Artform Home Plans
Artform Design # 418.124.v6.ctb
© 2011-2020 Artform Architecture 403.431.9589
Sweet Peekaboo
Lot 57 Lorden Commons
Londonderry, NH

Sweet Peakboo

Lot 57 Lorden Commons

Londonderry, NH

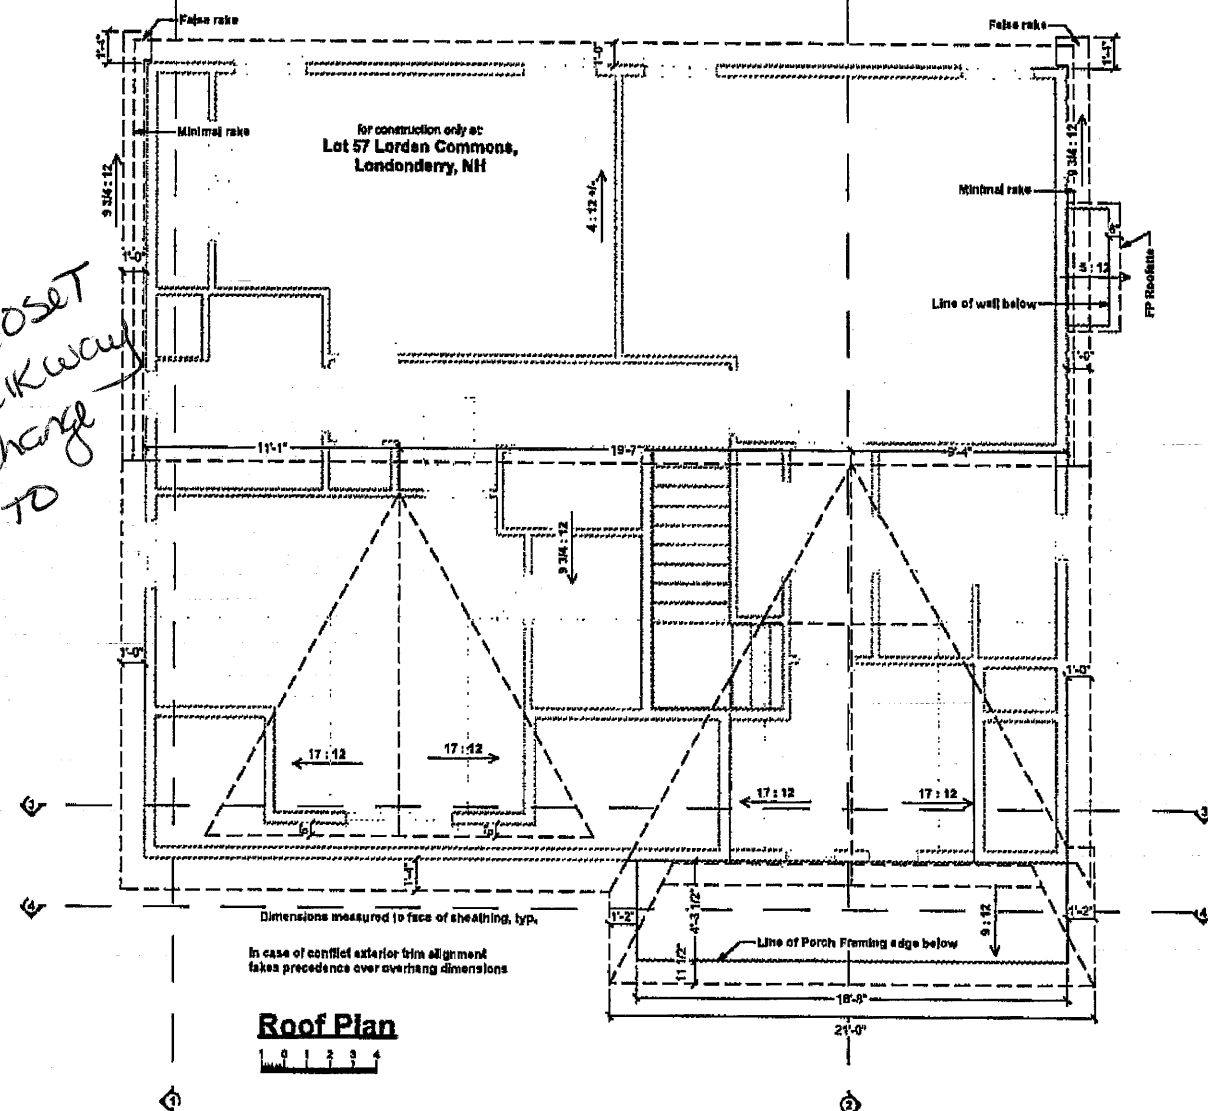
Remove closet
more walkway
over + change
vanity to
7'

SWEET PEELABOO
ROCK/SEK/HARDY
LOT 86

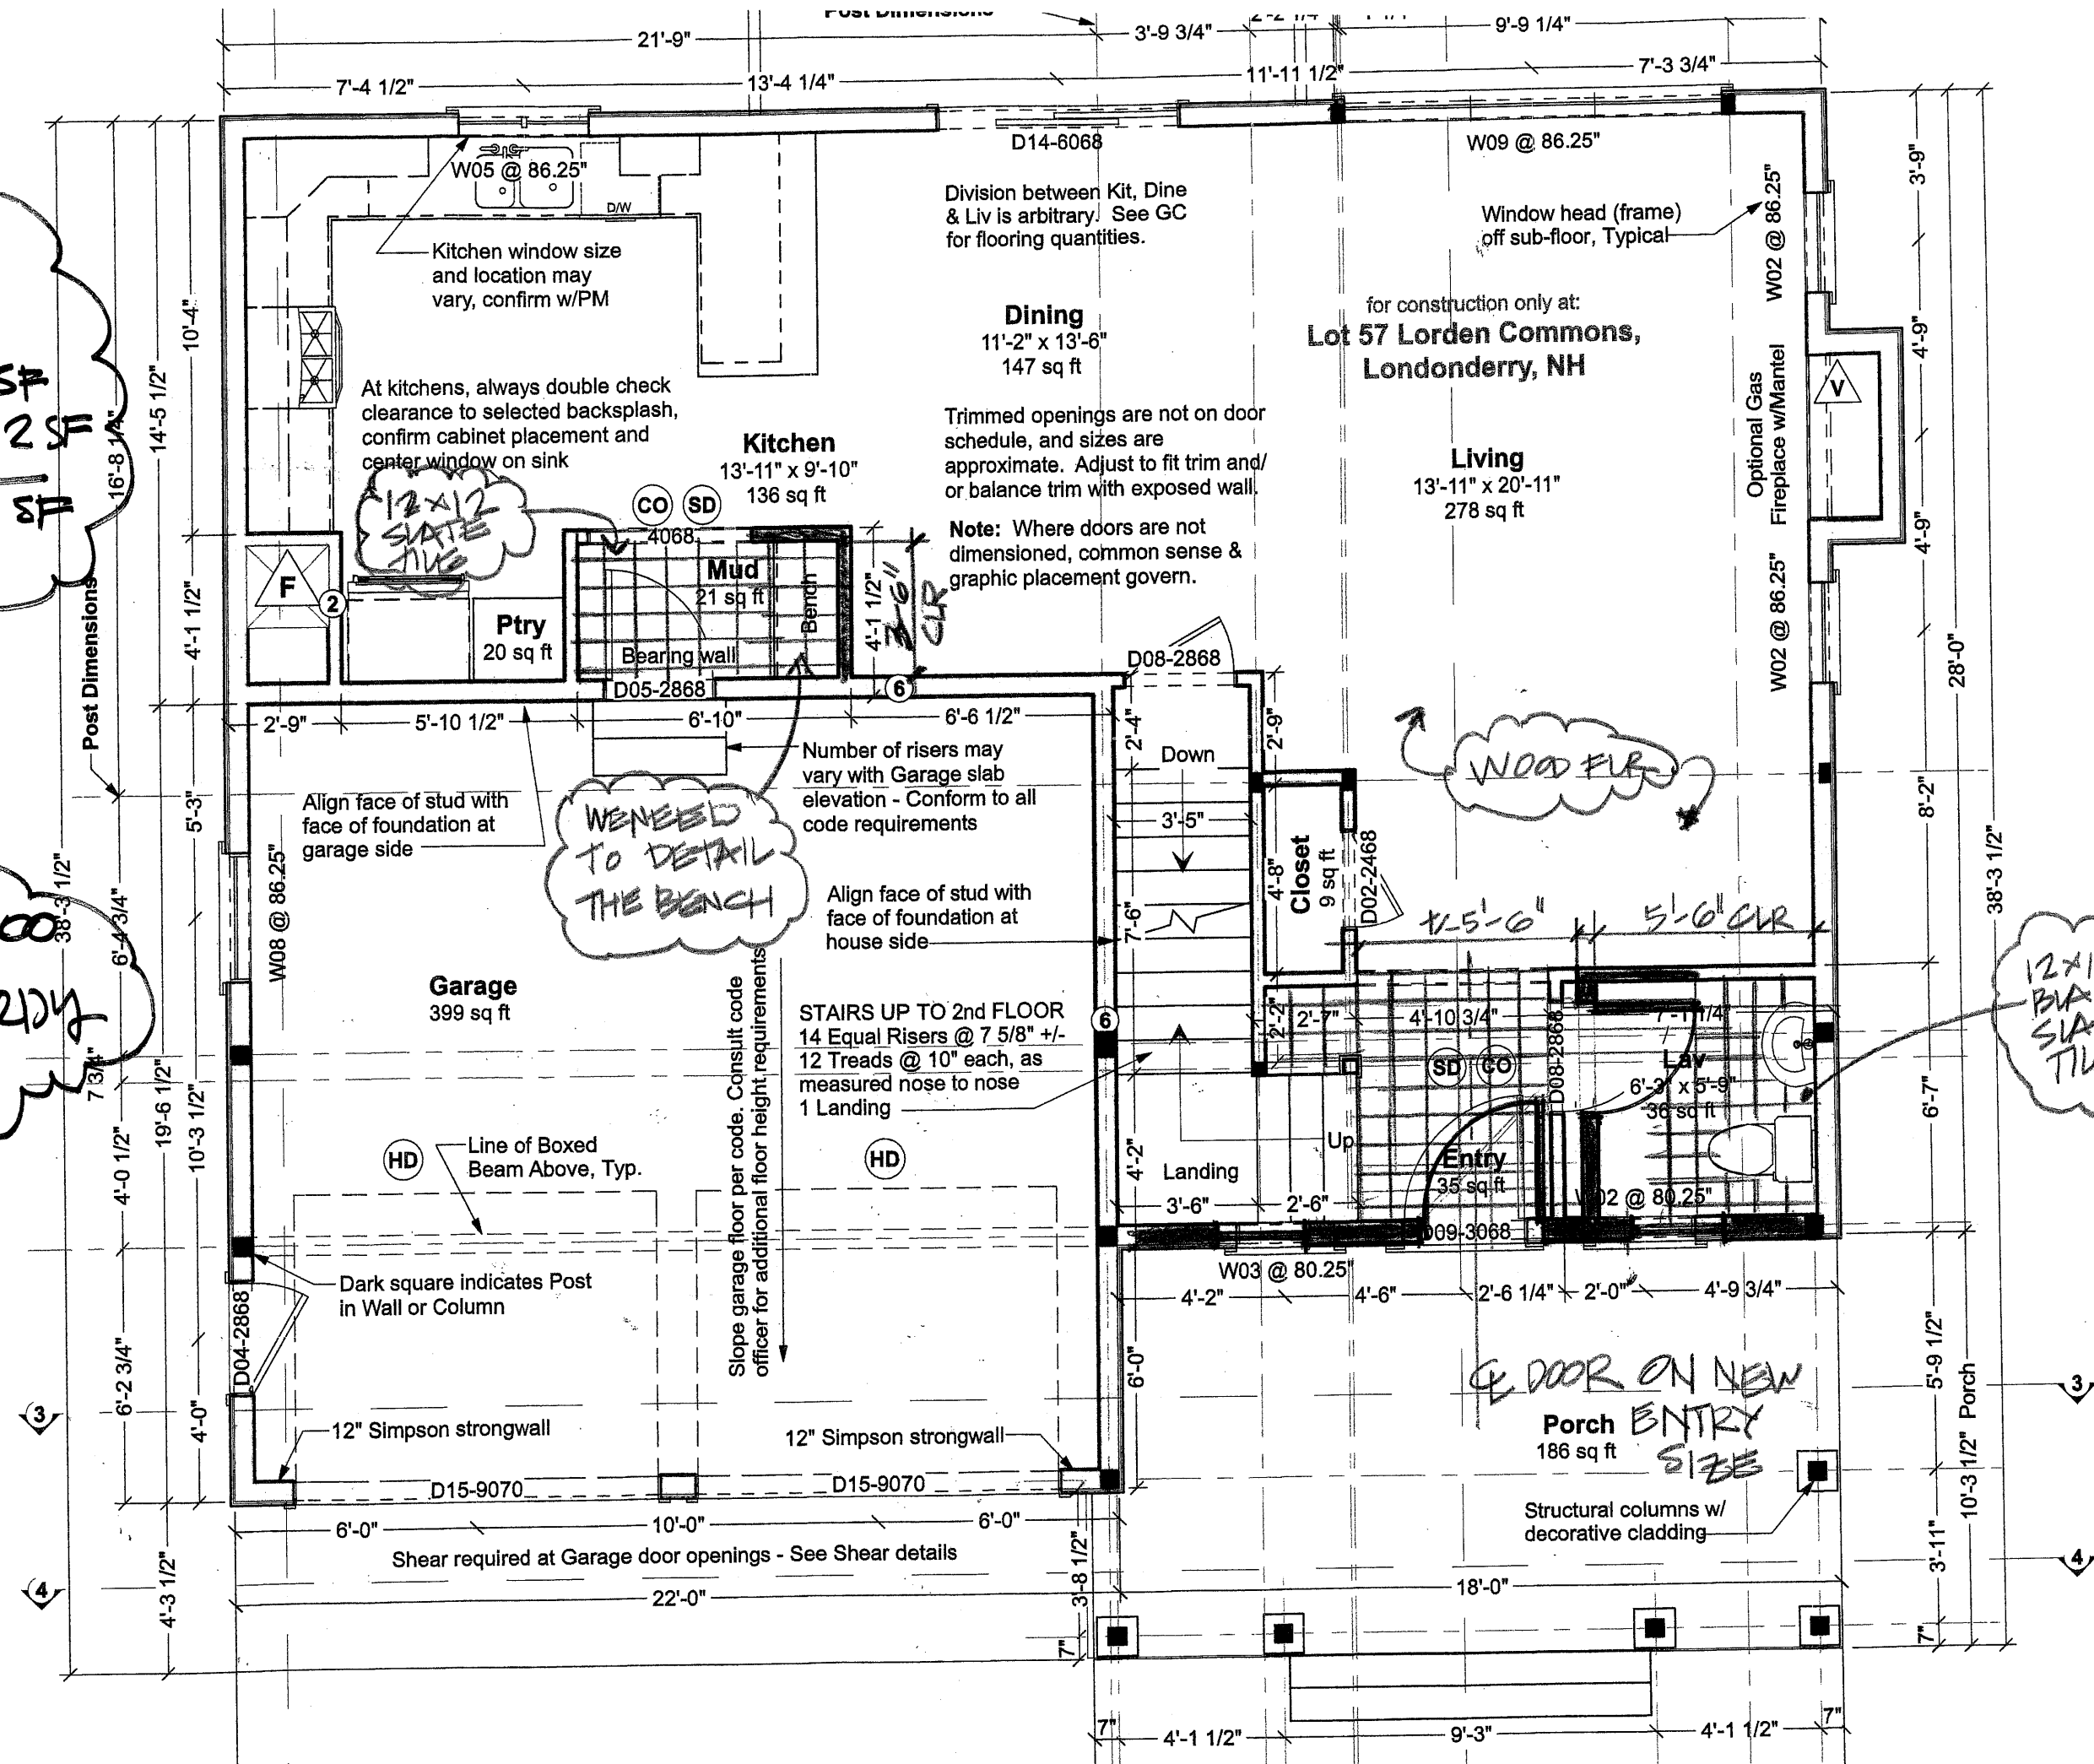
WE NEED
TO DETAIL
THE BENCH

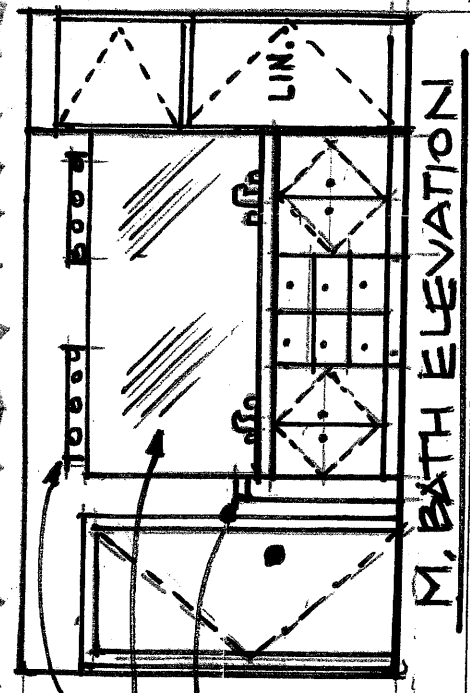
GLASS DOOR ON NEW
ENTRY
SIZE

ROB ~~CH~~ER
HARBY
LOT 86

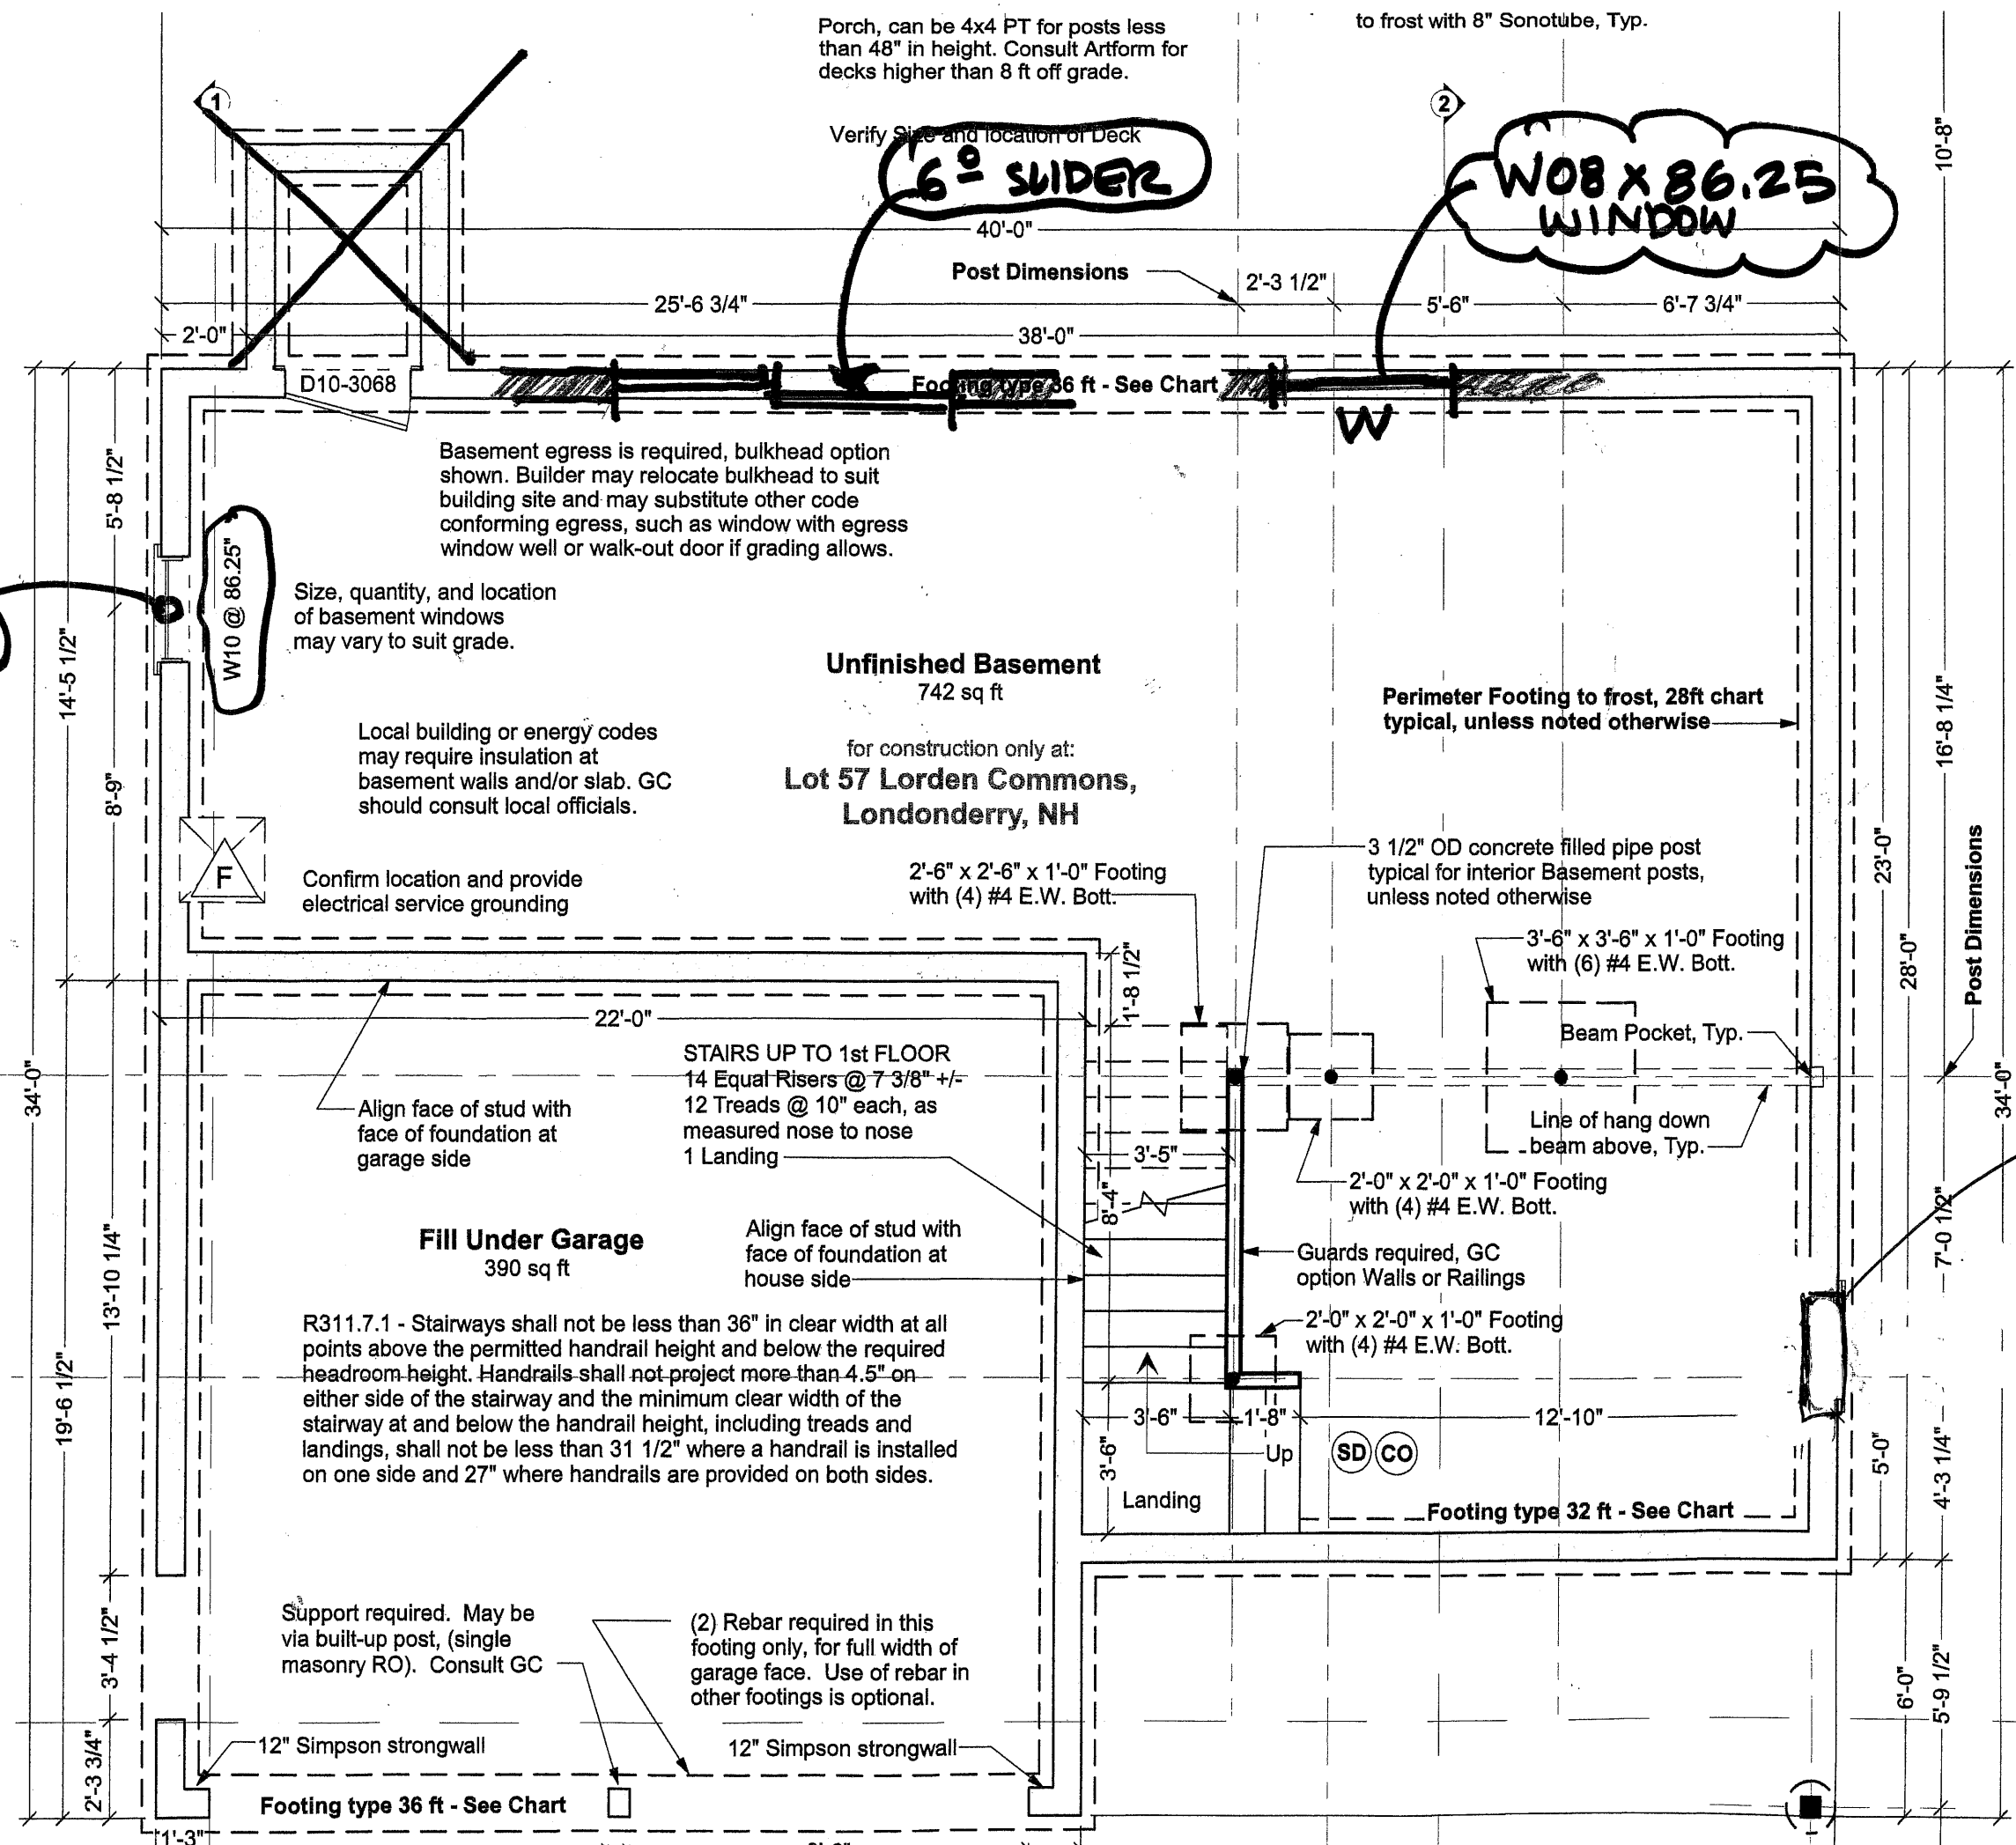
LEAVE
THIS
IN
